STAFF REPORT COMMUNITY DEVELOPMENT DEPARTMENT

HEARING DATE: 5/6/2021
 TO: Planning & Zoning Commission
 FROM: Alan Tiefenbach
 208-884-5533
 Bruce Freckleton, Development Services Manager
 208-887-2211
 SUBJECT: H-2021-0018
 Jump Creek North Fourplex CUP

Conditional Use Permit (CUP) to allow 7 fourplexes (28 units) on 2.2 acres in the R-15 zone.

C. Site Plan (date: 1/31/2020)

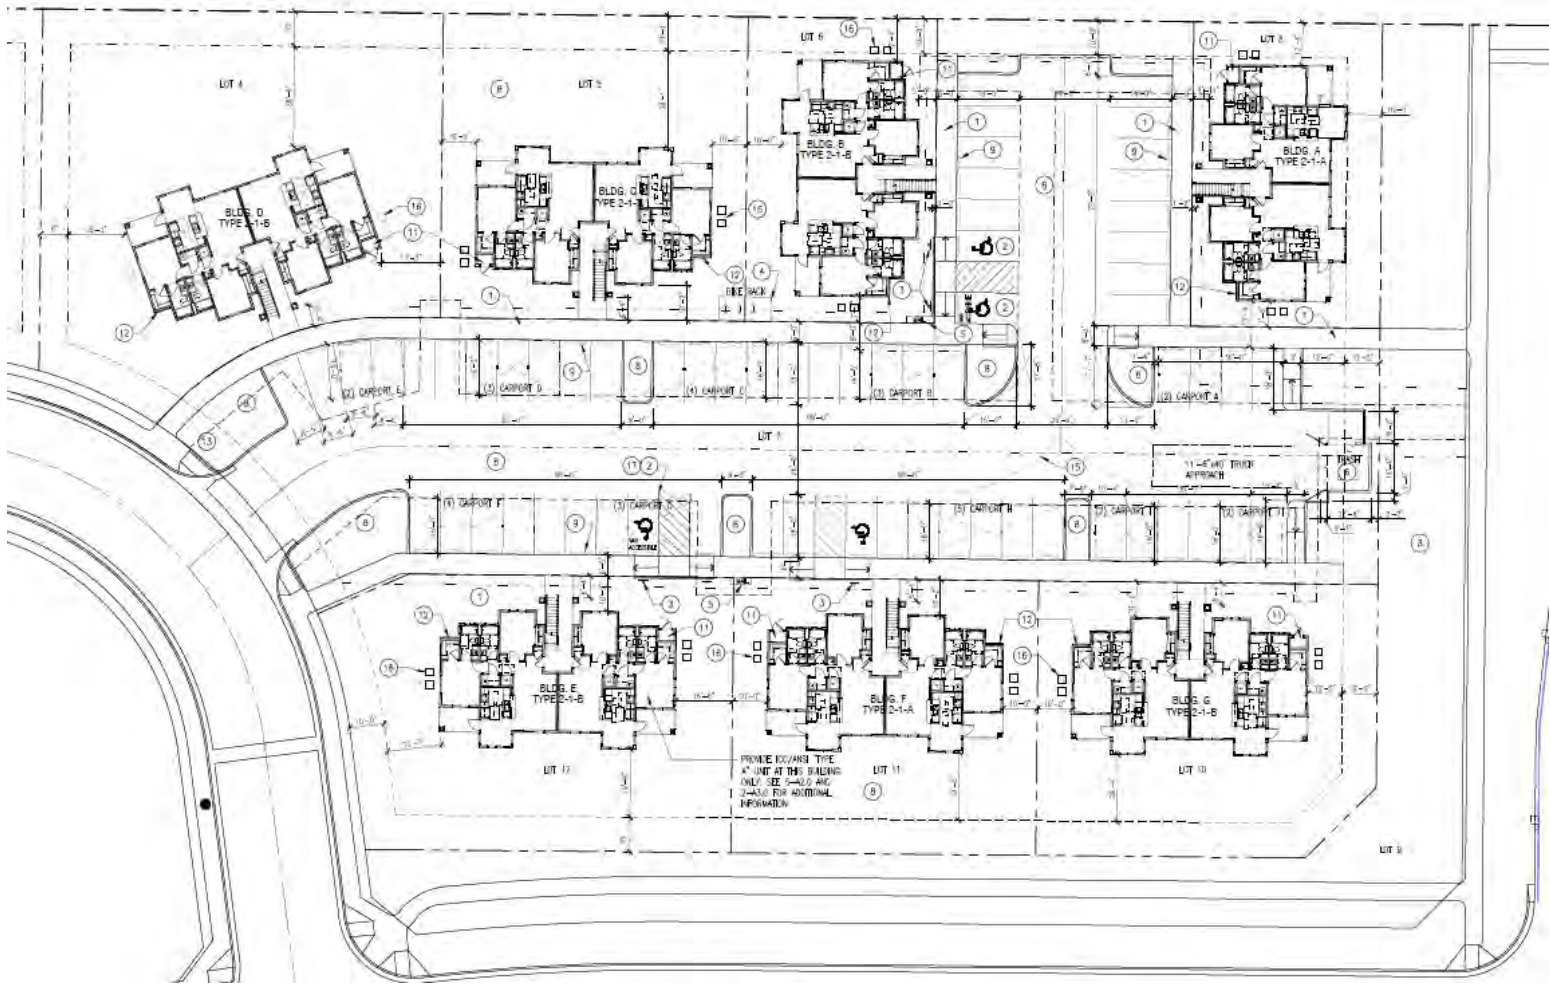
The proposal as submitted generally conforms to the site plan, landscape plan and conceptual elevations included with the development agreement except that one of the fourplexes on the northern side of the property is slightly reconfigured. The approved development agreement concept plan reflects two fourplexes on either side of a drive aisle, whereas what was submitted indicates three fourplexes on the west of the drive aisle, and a fourplex on the east side of the aisle. Two of the fourplexes have also been rotated on their axis 90 degrees.

The site plan and landscape plan indicate the minimum 10’ setback is met along all perimeter property lines. The submitted floorplans indicate patios and decks on the units that are slightly less than the requirement. The applicant will need to submit floor plans at the time of CZC that demonstrate this requirement is met.

The applicant has noted the central mailbox already exists, although it is not indicated on the plans. The applicant has not provided any information regarding the management office and maintenance storage other than this will be built with the additional 44 units of multifamily that may be part of Jump Creek No. 7 and requires a separate CUP approval. **The Planning Commission should determine whether this is acceptable request given Phase 7 has not been approved through conditional use yet, or whether one of the 28 units proposed with this particular phase (Phase 4) should be temporarily reserved for this purpose until Phase 7 is constructed.**

The site indicates 65 parking spaces that are 18 feet in length with wheel stops and a one-foot overhang onto a 6-foot sidewalk. The site plan shows 30 of these parking spaces to be covered, and conceptual elevations have been submitted of the carports. However, the conceptual elevations do not indicate architecture and materials other than prefinished metal. At the time of Certificate of Zoning compliance, the applicant shall submit color elevations that reflect that the architecture of the covered carports utilizing similar materials and architecture as that of the fourplexes as well as meet all requirements of the Architectural Standards Manual (ASM).

3. The site plan and landscape plan submitted with the Certificate of Zoning Compliance application shall be revised to depict a interim management office, maintenance storage area and a directory map of the development at an entrance or convenient location for those entering the development as set forth in UDC 11-4-3-27B.7:

- b. The site plan/landscape plan shall indicate the location of the central mailbox.
4. At the time of Certificate of Zoning Compliance (CZC), the Developer/Owner shall submit a common open space exhibit that meets the requirements of UDC 11-4-3-27-C.

D. Landscape Plan (date: 1/31/2020)

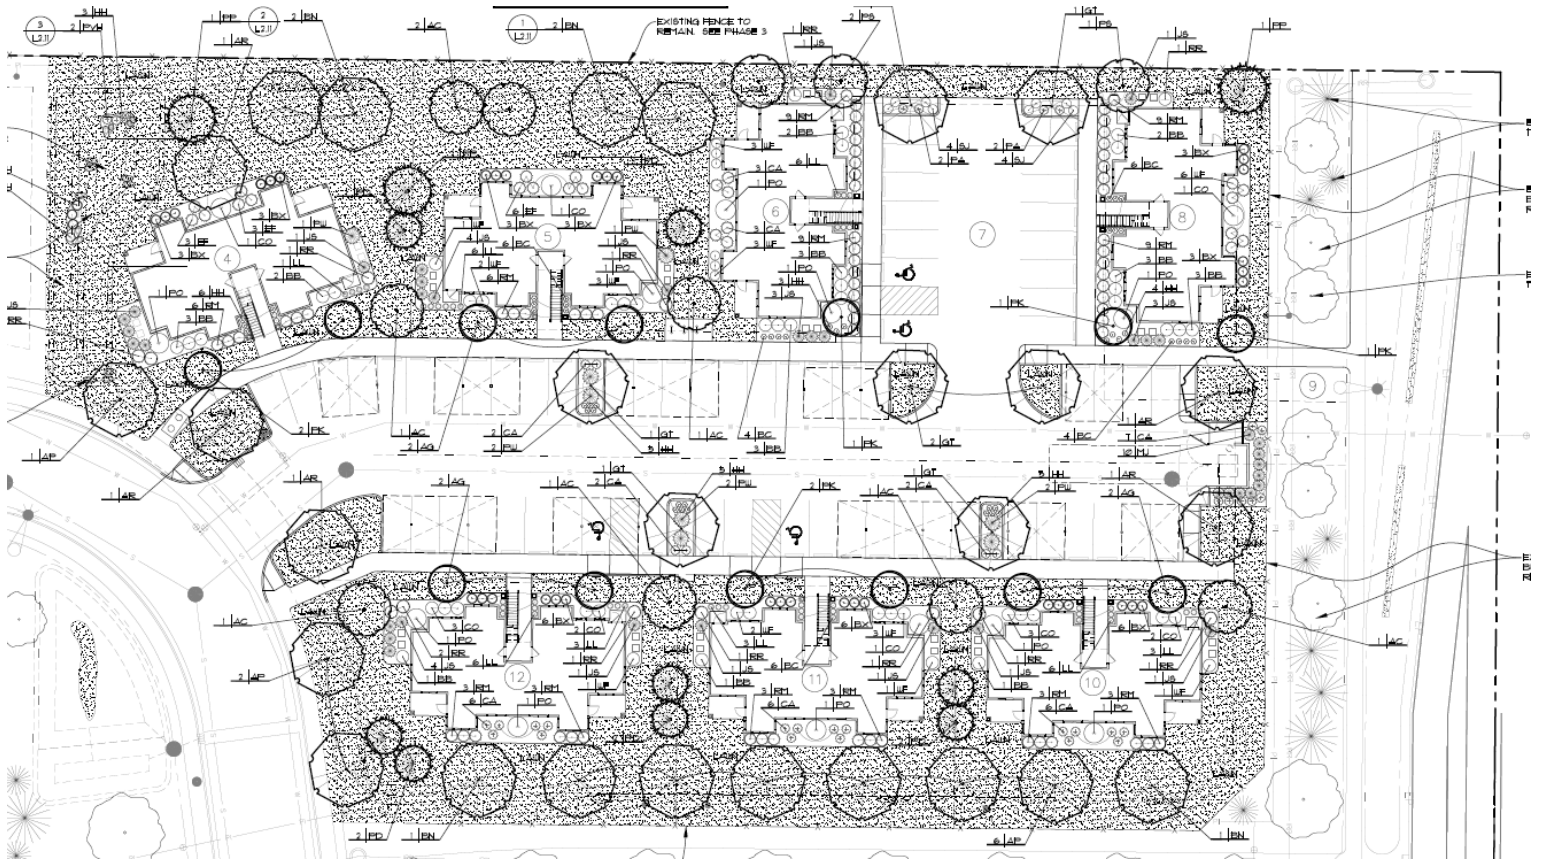
The landscape plan depicts 6' wide sidewalks along both sides of the access road and parking lots.

UDC 11-3B-8 requires a five-foot minimum landscape buffer adjacent to parking, loading, or other paved vehicular use areas, with no grouping of parking spaces to exceed 12 in a row without a parking island. The parking aisles and lot appears to meet all requirements, including

minimum amount of landscape plantings. The foundations of all fourplexes are landscaped with at least 3' of landscaping along their foundations as required by the Specific Use Standards listed in 11-4-3-27.

The landscape plan indicates there is existing fencing along the northern perimeter that is proposed to be retained. No other fencing is shown with this development. Any fencing should comply with UDC 11-3A-7.
